Interactive comment on “Comparison of Optimal Estimation HDO/H₂O Retrievals from AIRS with ORACLES measurements” by R. L. Herman et al.

Final Author Comments to reviewers of amt-2019-195, To anonymous Referee #4 We thank the referee #4 for constructive comments on the manuscript amt-2019-195, “Comparison of Optimal Estimation HDO/H₂O Retrievals from AIRS with ORACLES measurements.” We have addressed all comments from the referee.

268
269
270
271
272 **Figure 2.** ORACLES aircraft profiles (thin grey line segments) over the southeast
273 Atlantic Ocean to the west of Africa are matched to AIRS fields of view (FOVs) in loose
274 spatial match (open circles) and tight spatial match within 30 km (closed circles) for eight

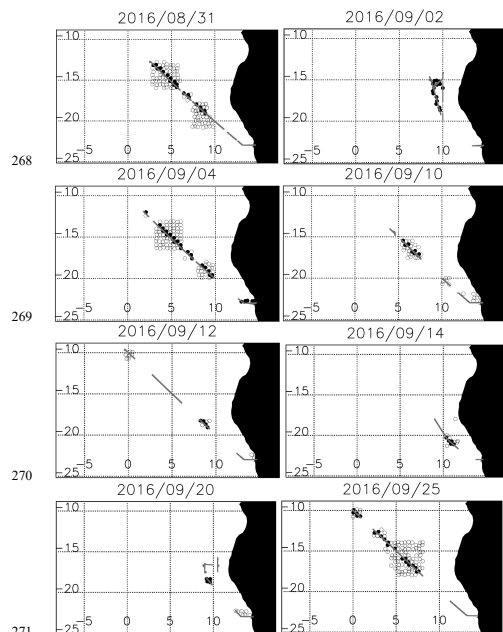
(1) Figures23: A little colour/shading would be useful to help distinguish land/ocean. It is difficult to see the aircraft track through the AIRS IFOV markers. How many aircraft profiles are each subfigure?

(2) We will modify the Figures 2 and 3 to be easier to read. There are typically 3 to 6 aircraft profiles per subfigure. They overlap spatially as the aircraft flies the same diagonal path.

Fig. 2. Revised Figure 3

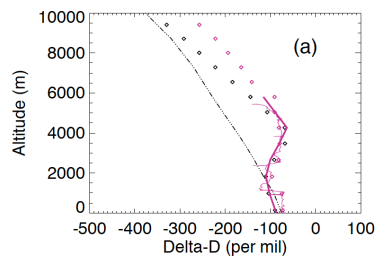
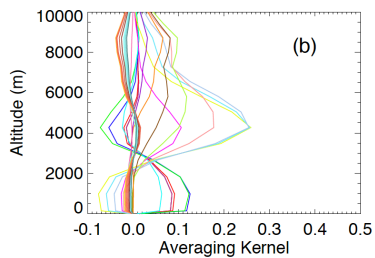
(1) Figure 4: Subfigure headings are missing (a,b).

(2) We have added the subfigure headings (a) and (b) to the figure.

(3) Revised Figure, now renumbered as Figure 3.
